R21BN

DATE: August 4, 2022
TO: Blue Bird Owners
Subject: R21BN: Hydraulic Brake Line Rub on Ford 7.3L

NHTSA Recall Number: 21V-778 School Bus

SUBJECT: R21BN: Hydraulic Brake Line Rub on Ford 7.3L

Illustration 1

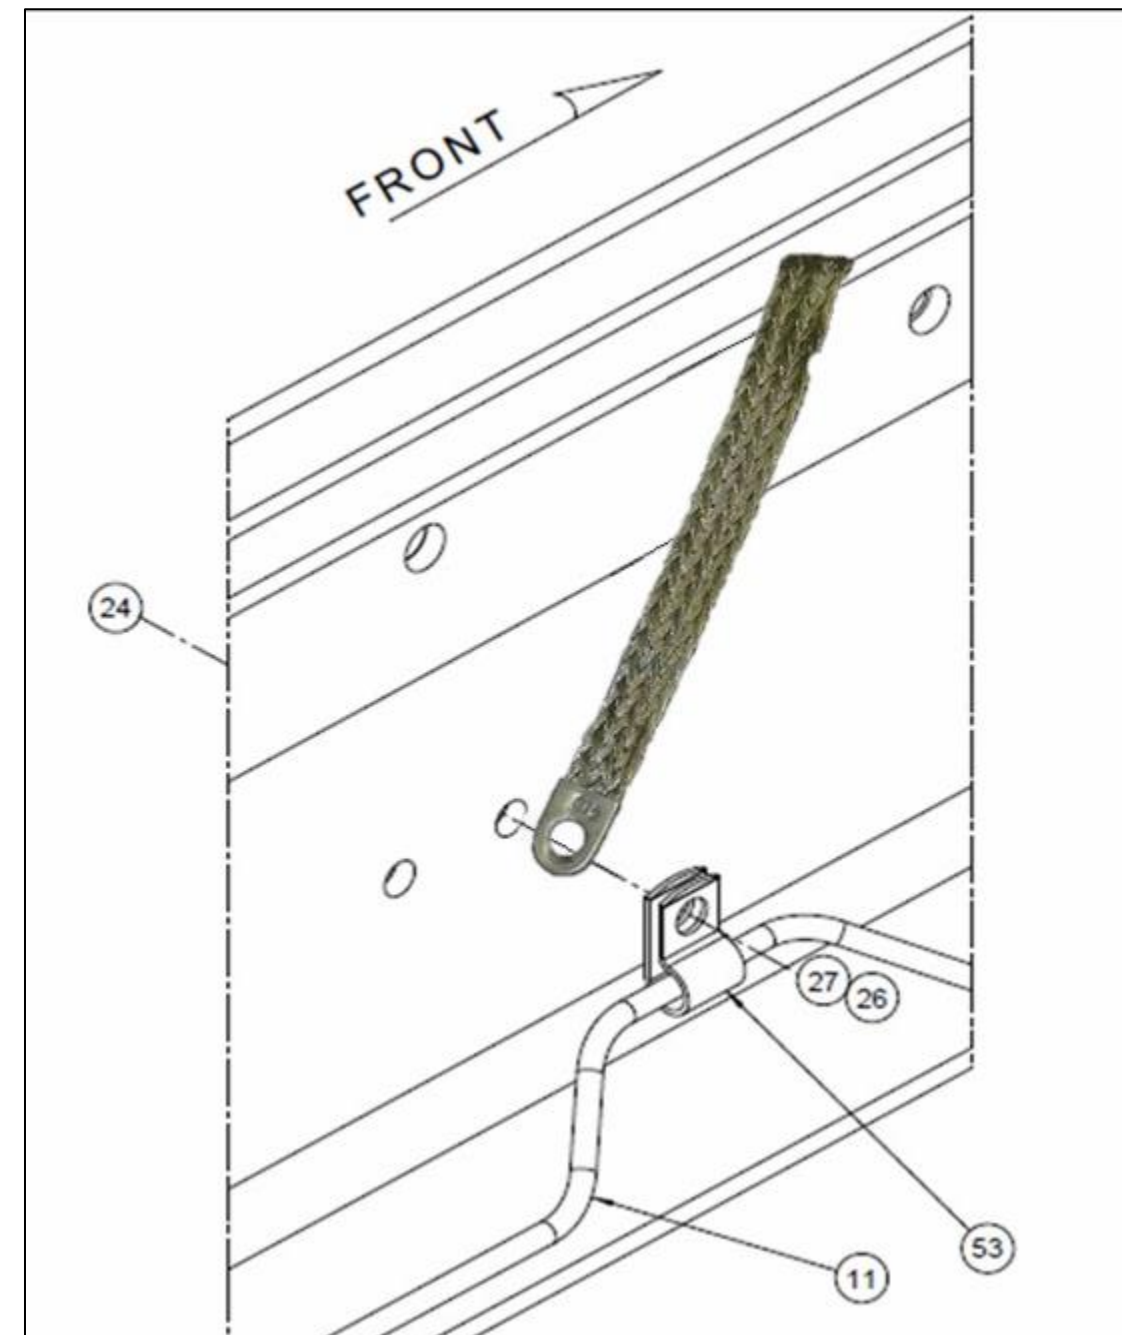
Issue: The left-hand, front hydraulic brake line on certain units may not be properly secured.

- Locate the left-hand front brake line, inside the frame rail, rear of the front motor mount.
- Inspect for a “P” clamp (Item #53) securing the hydraulic brake line to the frame rail at the grounding strap.
 - If the clamp is installed, tight and positioned per Illustration 1, no further action is necessary.
 - If the clamp is missing or incorrectly installed, proceed to the next step.
- Locate the mounting fastener for the engine ground strap. Remove the locking nut securing ground strap to chassis and discard the nut.

Corrective Action: Install P-Clamp over brake line in a downward position, securing the brake line to the frame rail.

- Install P-Clamp 02024370 (Item 53) over brake line, oriented in a downward position, with the flat side of the P-Clamp against the frame rail.
- Insert capscrew and washer (Items 26 & 27) thru the P-Clamp, ground strap and frame rail.

*IMPORTANT: The stack of components is critical. Proper sequence is frame, ground strap then P-Clamp
Do not install P-Clamp between frame and ground strap.*
